Our Ref:BS:KL:239566

7 May 2021

MP 10-0088 MOD 2 - PROPOSED INTERSECTION UPGRADES NORDS WHARF ROAD AND PACIFIC HIGHWAY AND AWABAKAL DRIVE

Plan of Traffic Signal Controlled Intersection

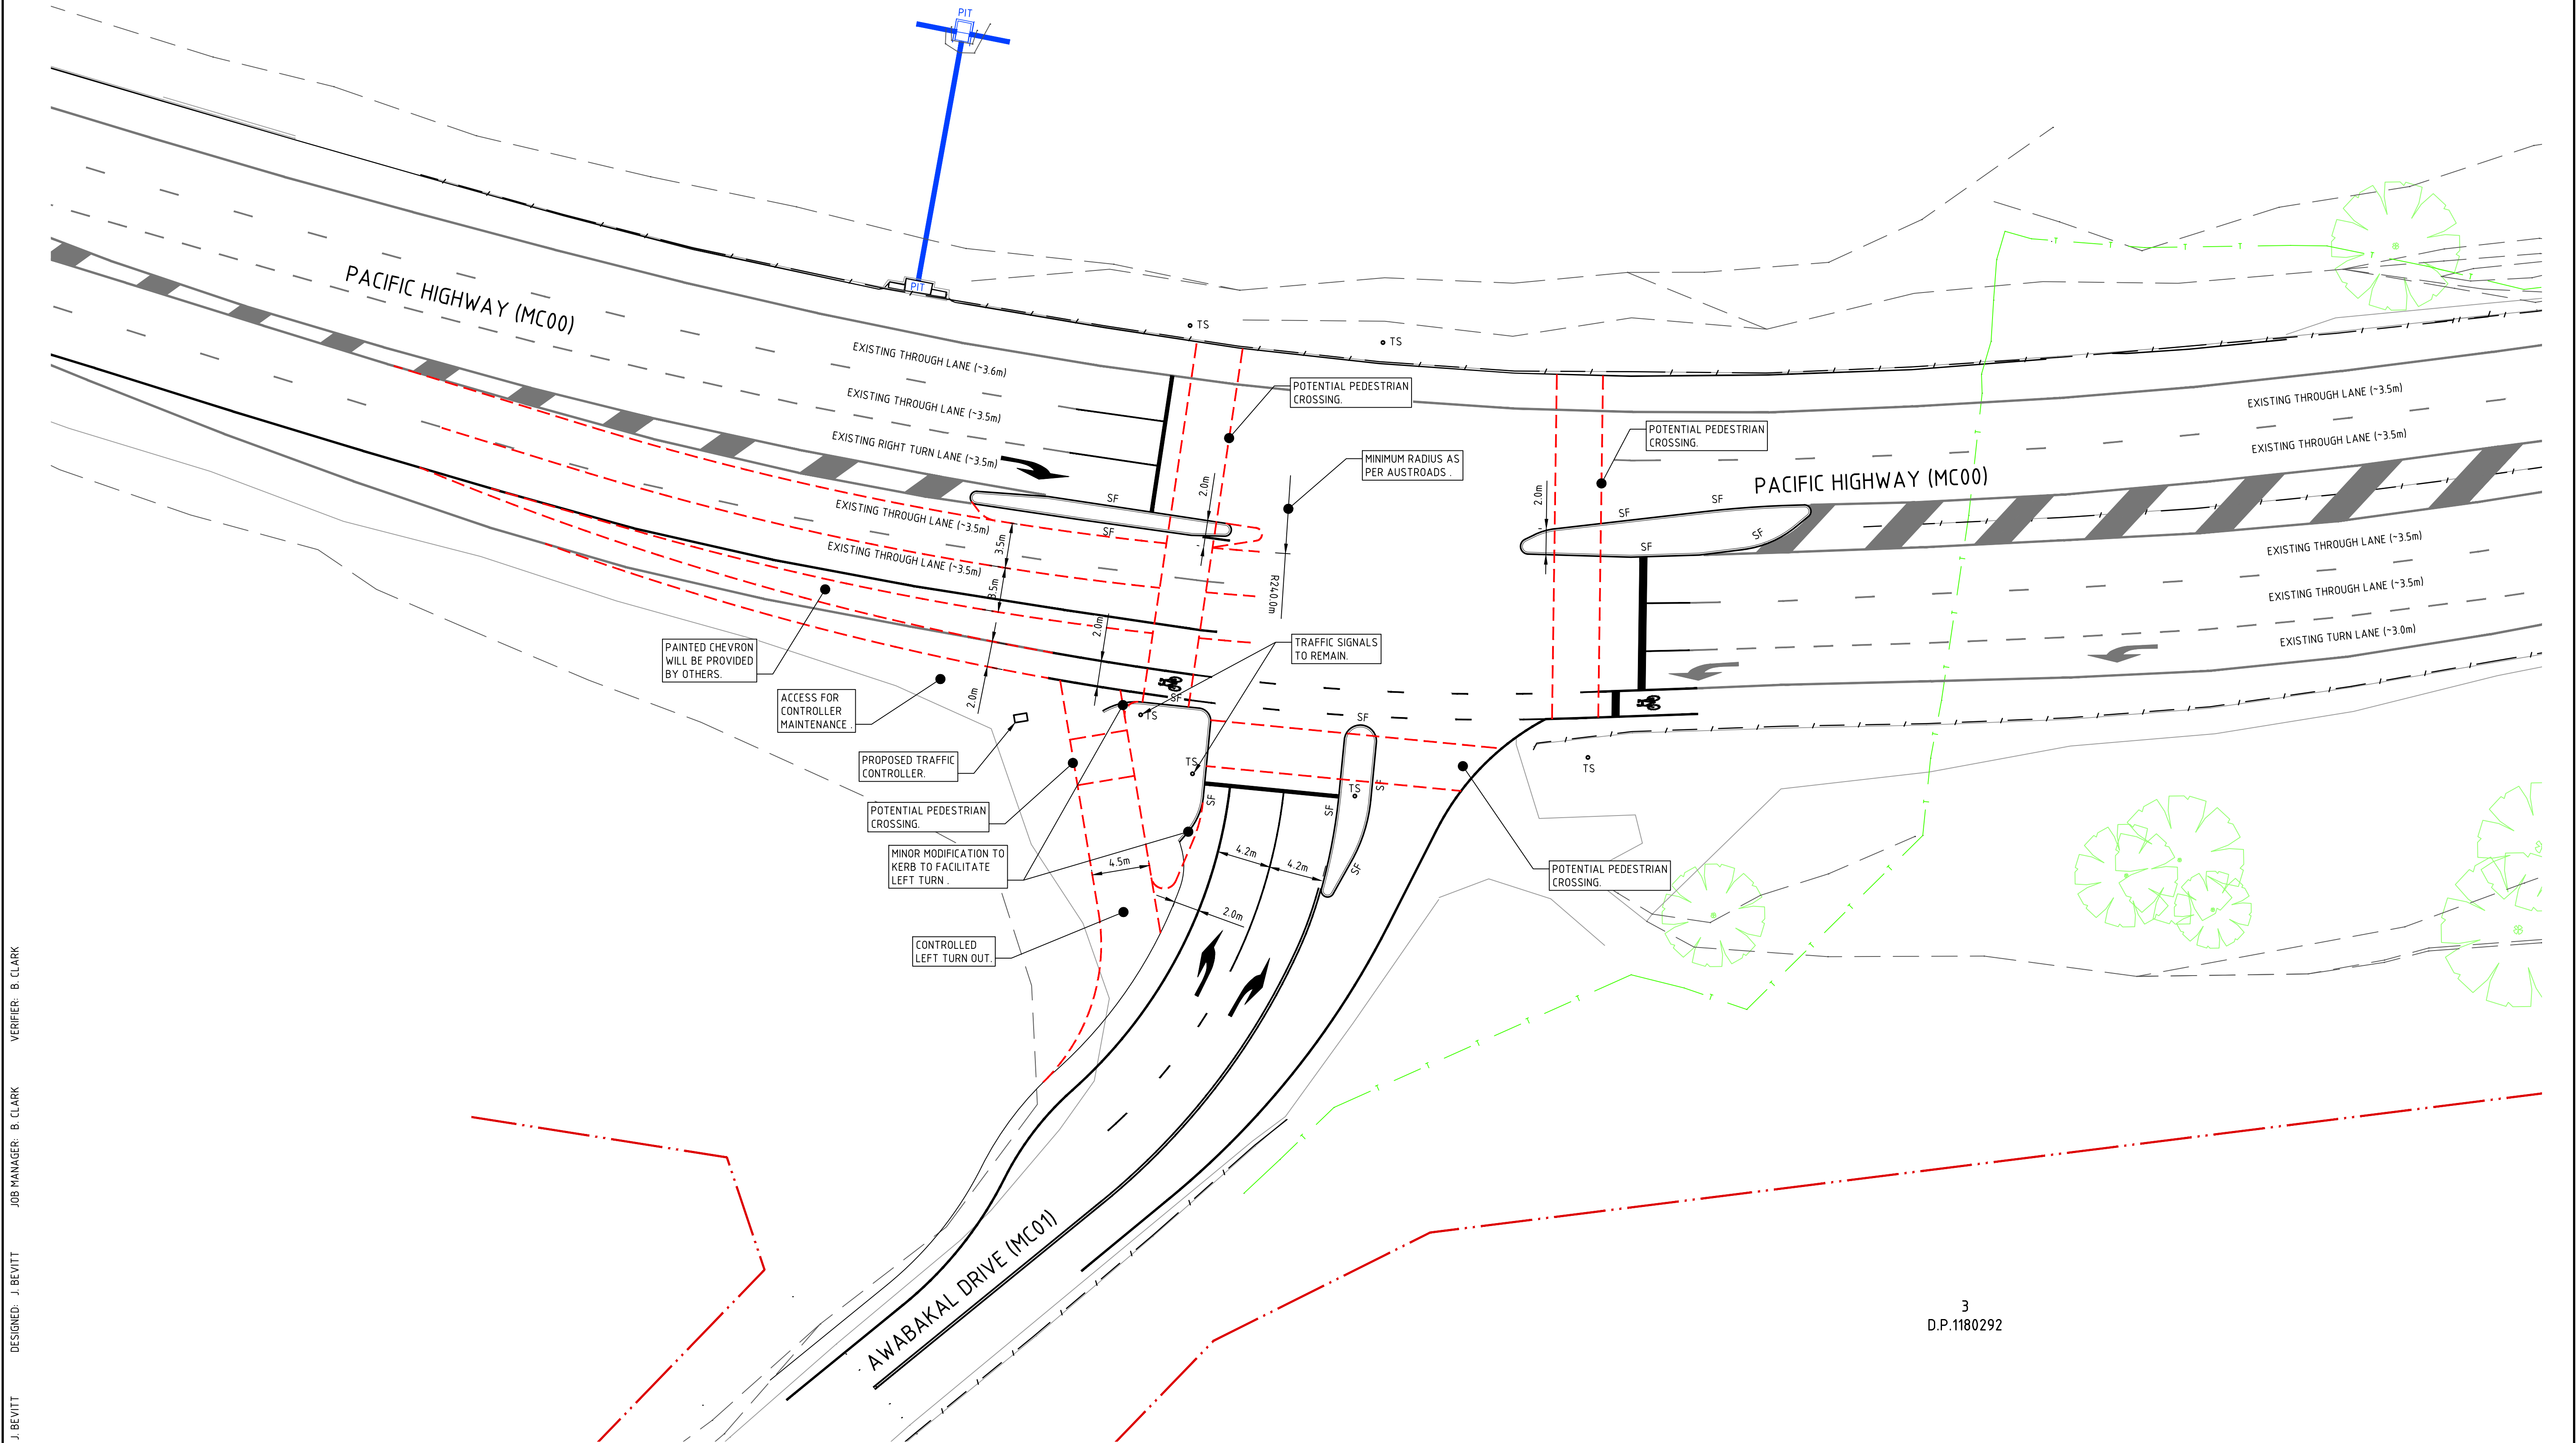
Note: This intersection type of intersection (Signalised Seagull) is no longer supported by TfNSW, for this environment.

On reviewing the data available TfNSW advises that the preferred layout, (for the Pacific Highway / Awabakal Drive Intersection relating to this Development), should be designed and constructed as a **full TCS (Traffic Control Signal) intersection**.
